THE MARYLAND ZOO IN BALTIMORE

PERIMETER GATE REPORT

SEPTEMBER 2021

#1 VET HOSPITAL GATE

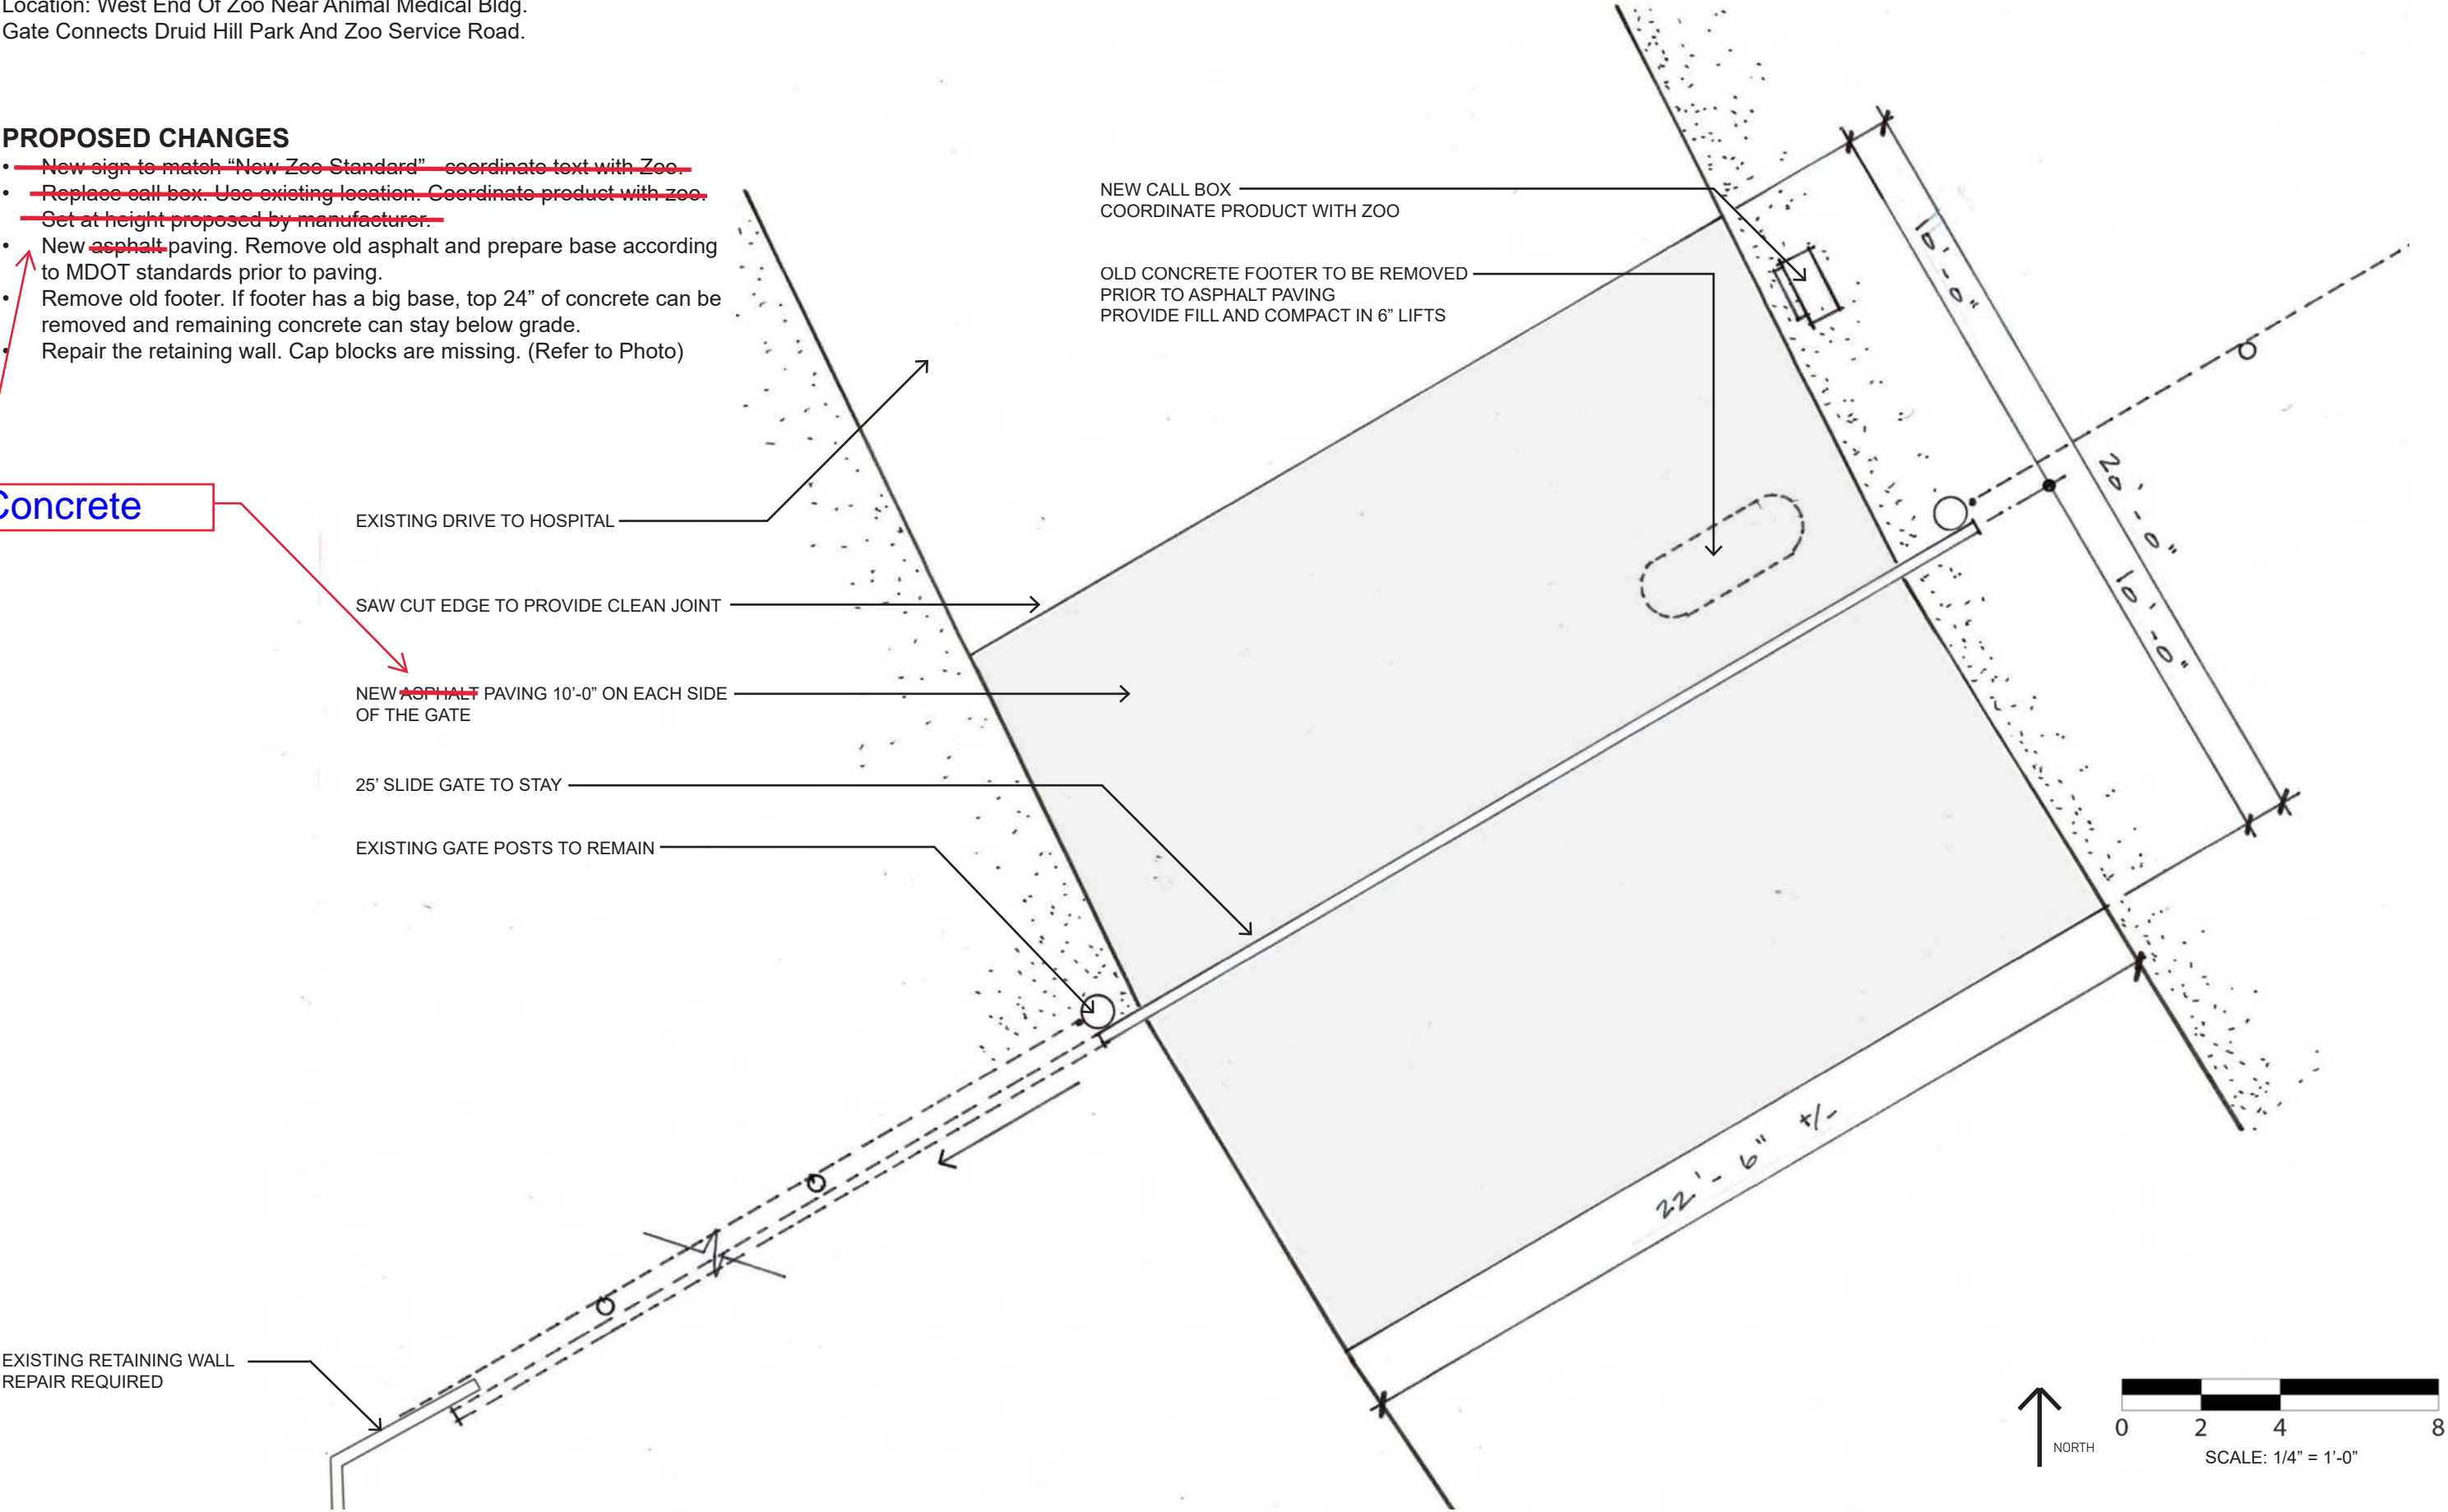
- ~~New sign to match "New Zoo Standard" coordinate text with Zoo.~~
- ~~Replace call box. Use existing location. Coordinate product with zoo.~~
- ~~Set at height proposed by manufacturer.~~
- New ~~asphalt~~ paving. Remove old asphalt and prepare base according to MDOT standards prior to paving.
- Remove old footer. If footer has a big base, top 24" of concrete can be removed and remaining concrete can stay below grade.
- Repair the retaining wall. Cap blocks are missing. (Refer to Photo)

Concrete

#2 EAGLE GATE

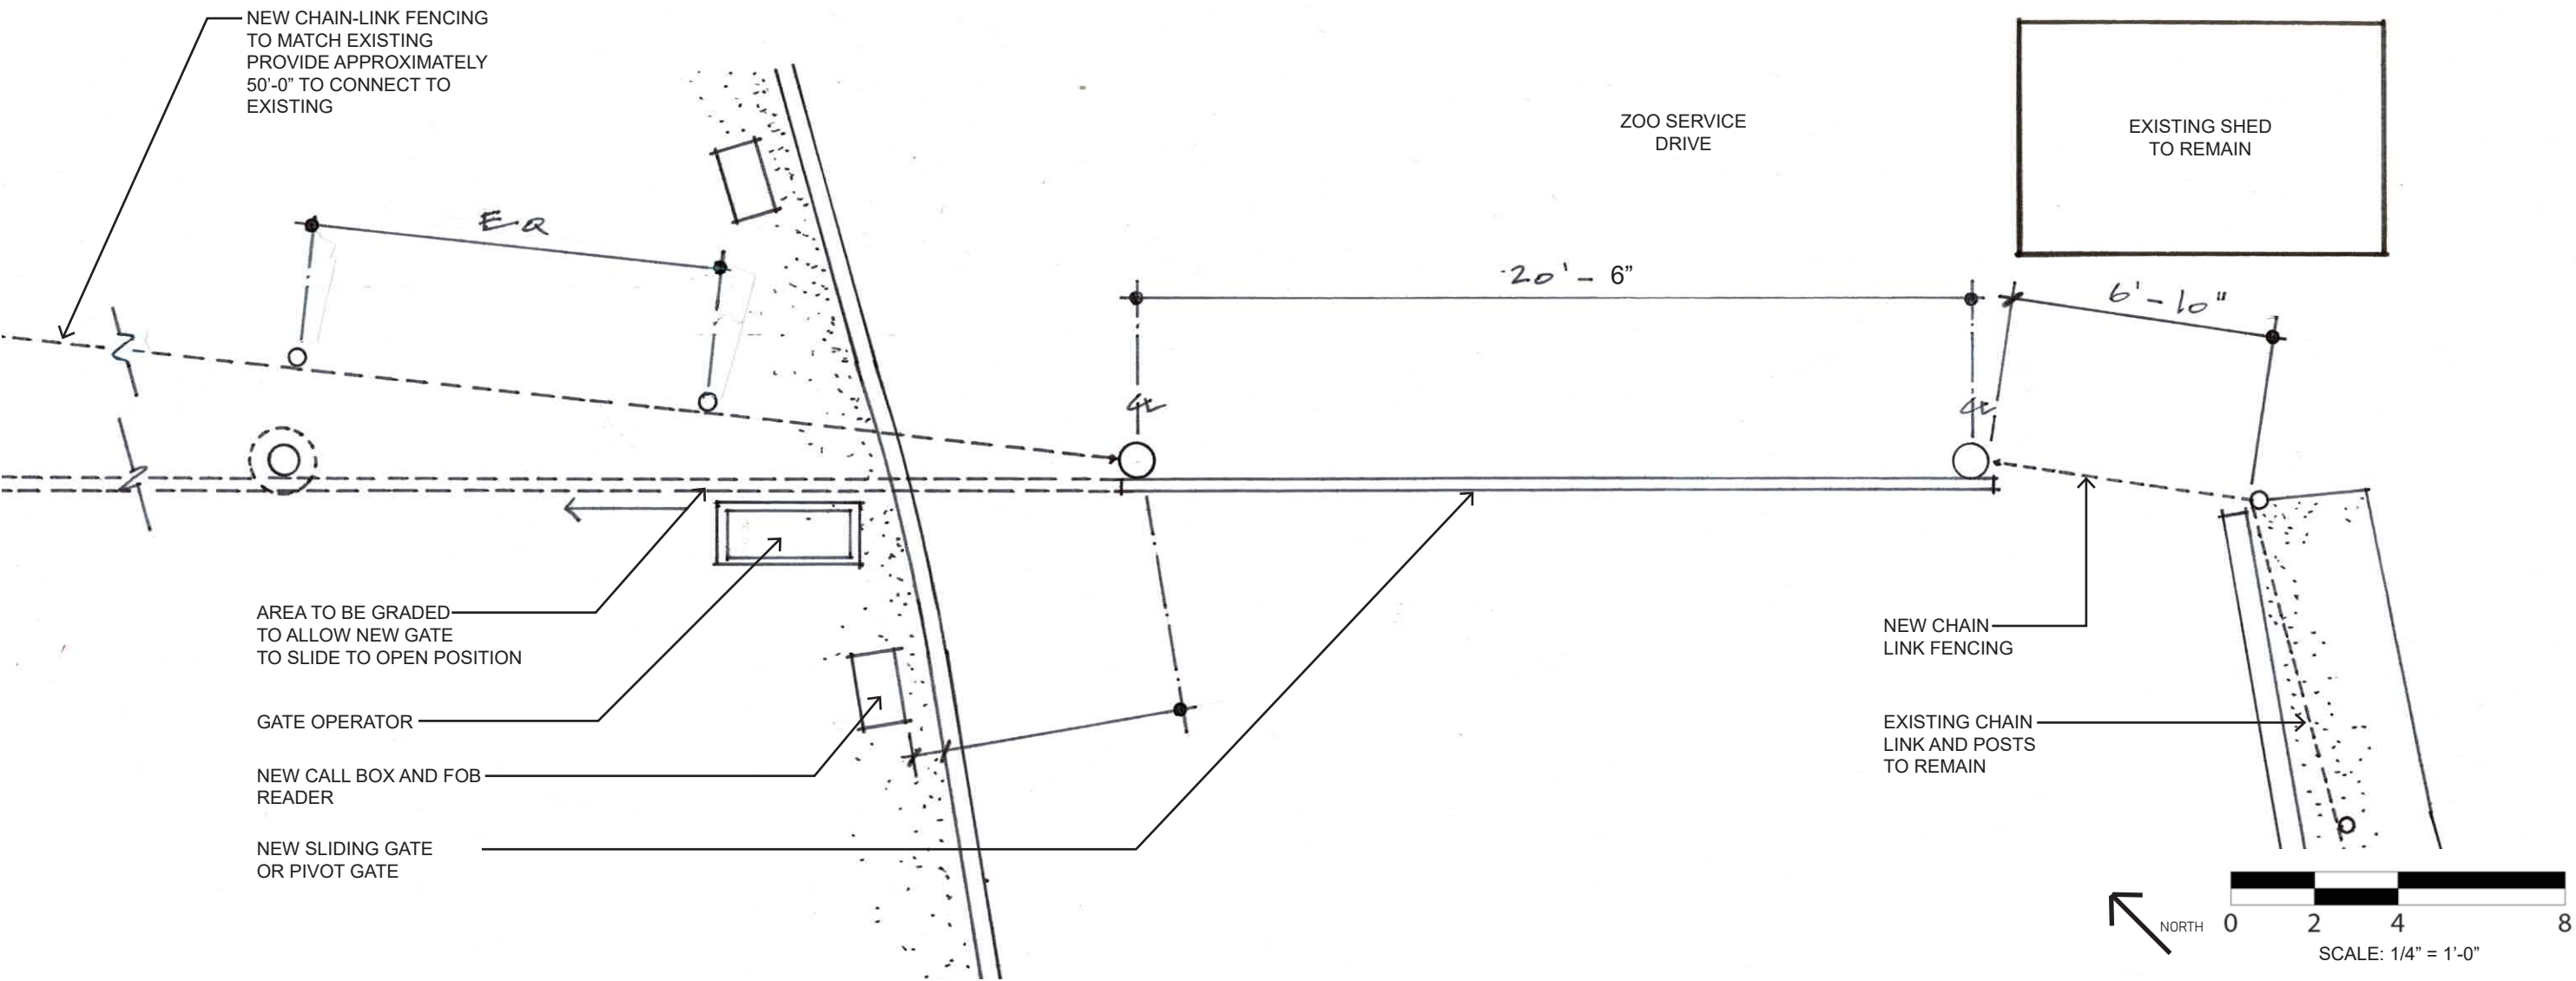
- ~~New sign to match "New Zoo Standard" - coordinate text with Zoo.~~
- Replace chain link fencing on both ends of Gate 2. Provide approximately 50'-0" of fencing.
- ~~Add a call box and FOB reader. Coordinate product with zoo. Set at height proposed by manufacturer.~~
- Regrade area at north west end of Gate 2. Regrade in order that the gate can slide open unobstructed.
- New 7' wide (curb to fence) ~~asphalt~~ pavement. Start from bollards and pave towards Eagle gate (120' of pavement). Remove existing pavement in that zone and repave.

concrete paving. extent to be confirmed during walkthrough

#3 COMFORT STATION VEHICLE

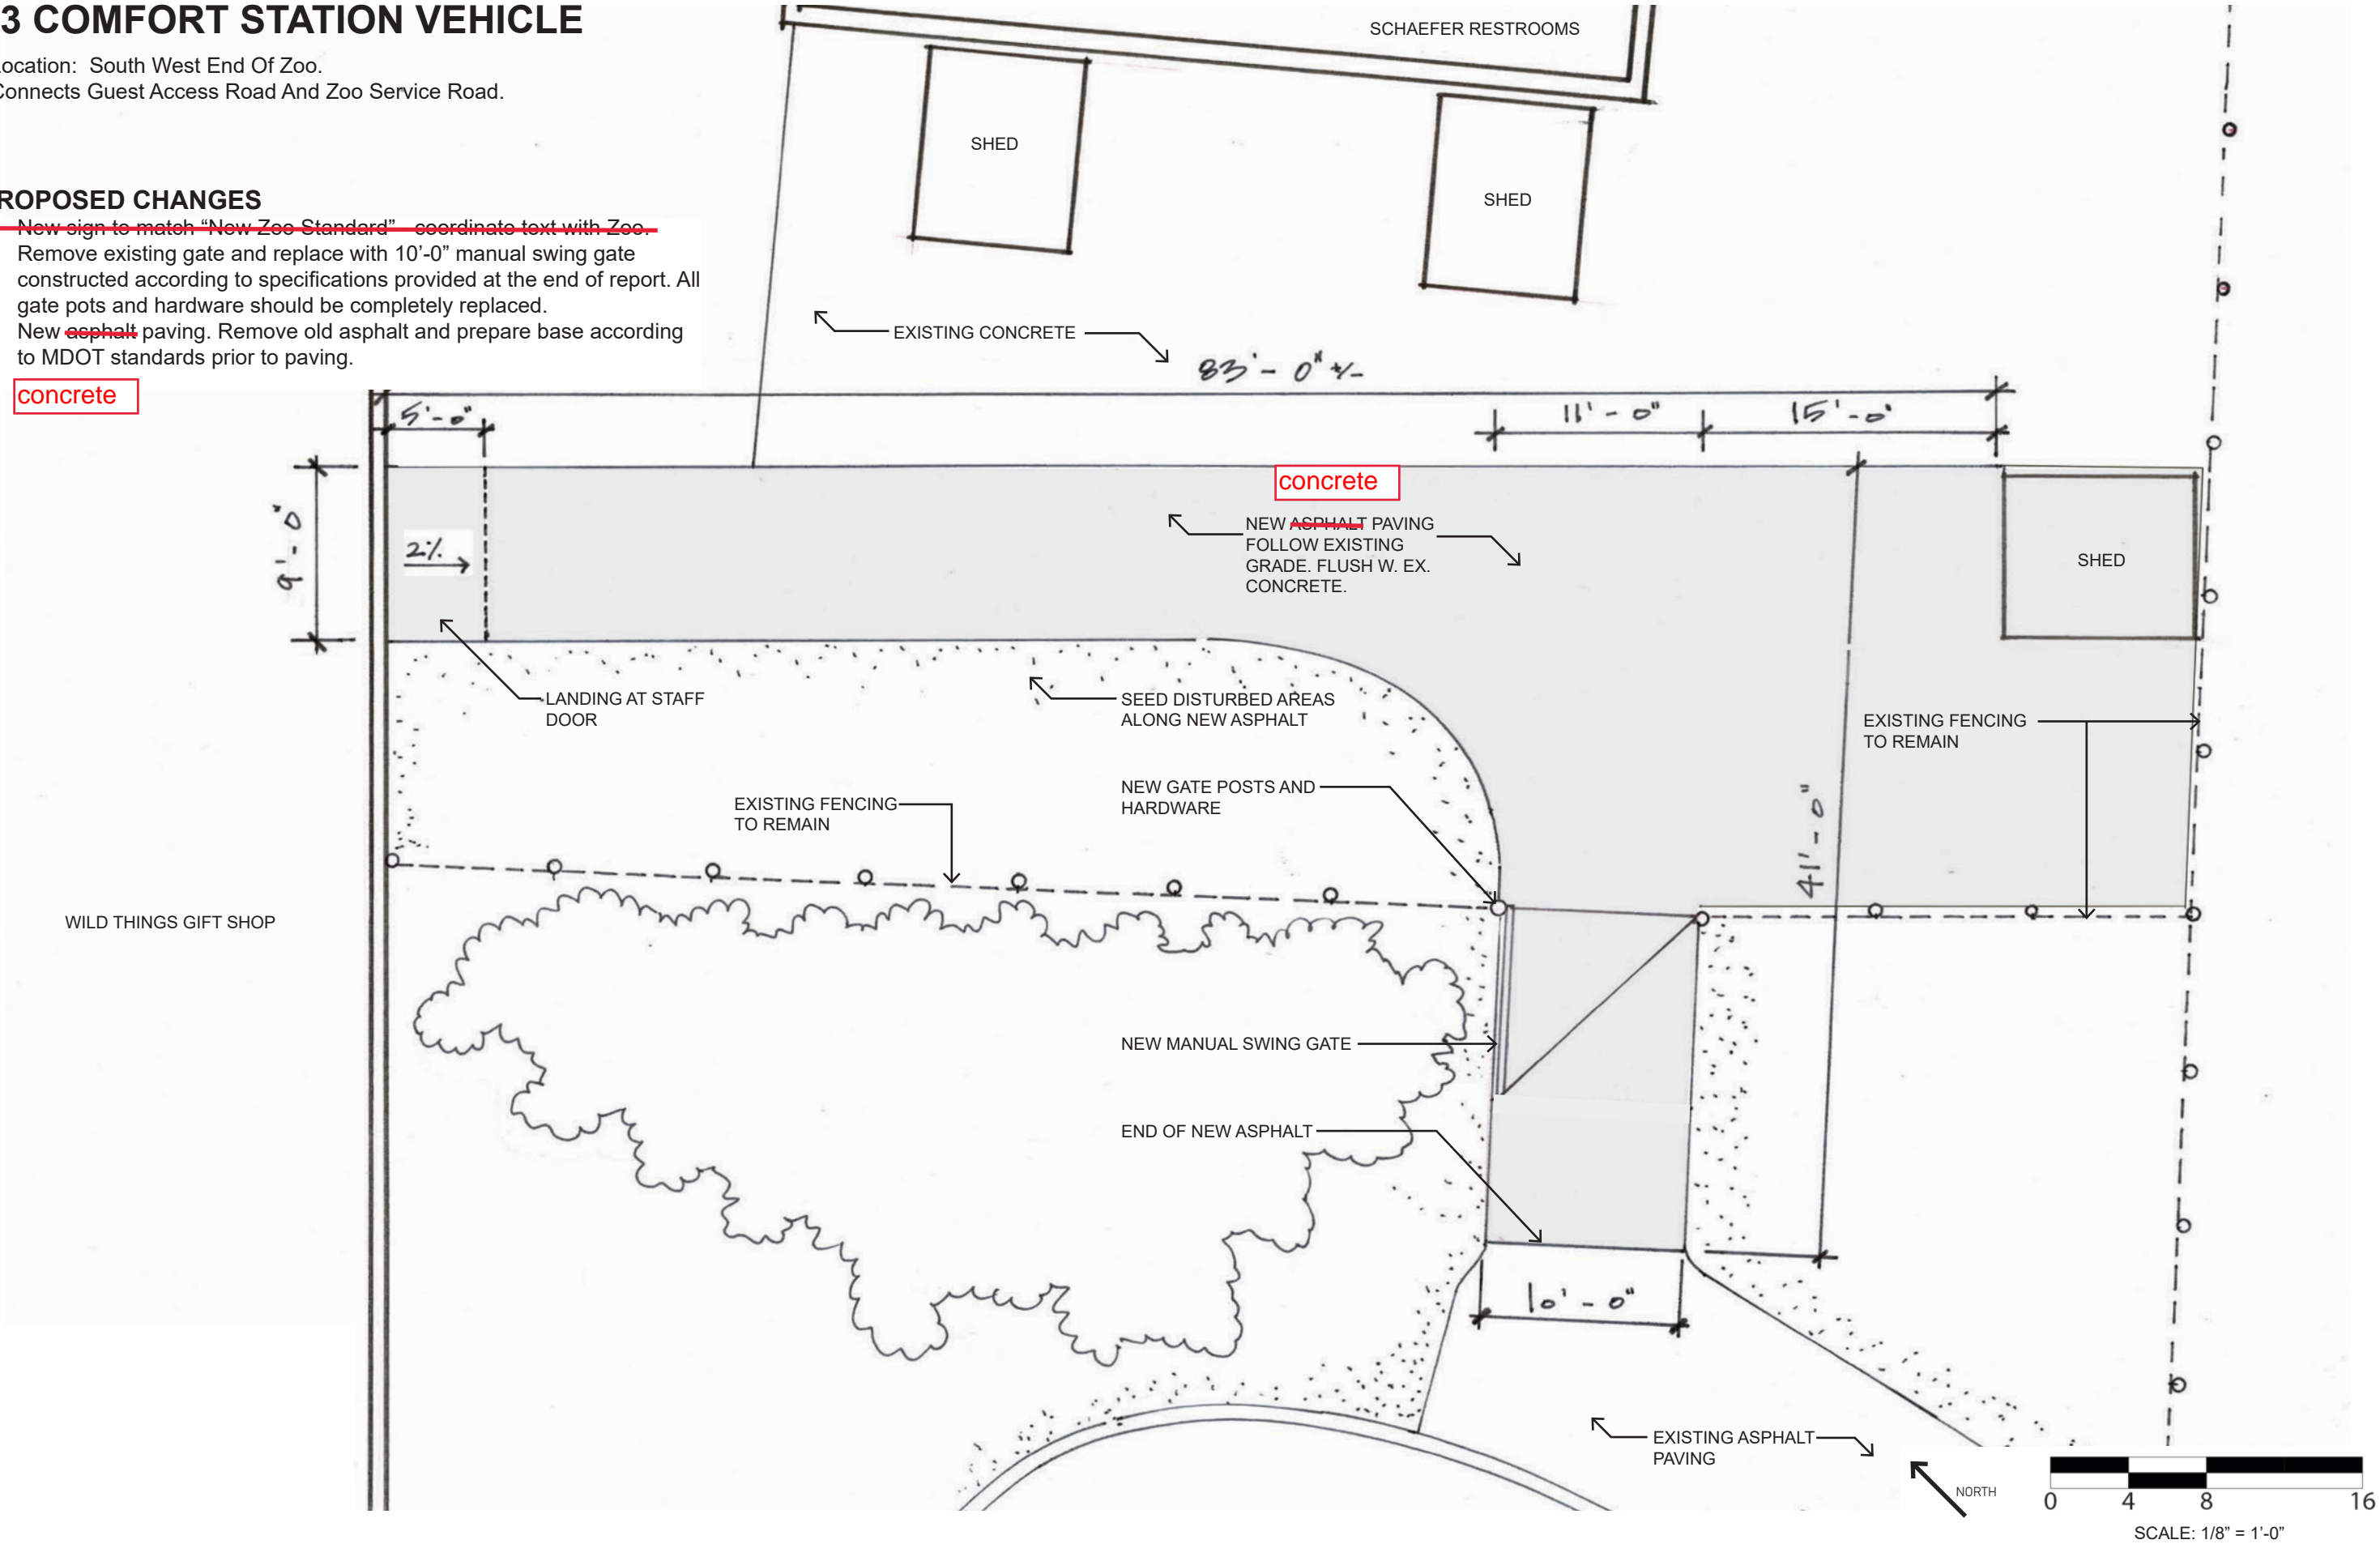
- ~~New sign to match "New Zoo Standard" coordinate text with Zoo.~~
- Remove existing gate and replace with 10'-0" manual swing gate constructed according to specifications provided at the end of report. All gate pots and hardware should be completely replaced.
- New ~~asphalt~~ paving. Remove old asphalt and prepare base according to MDOT standards prior to paving.

concrete
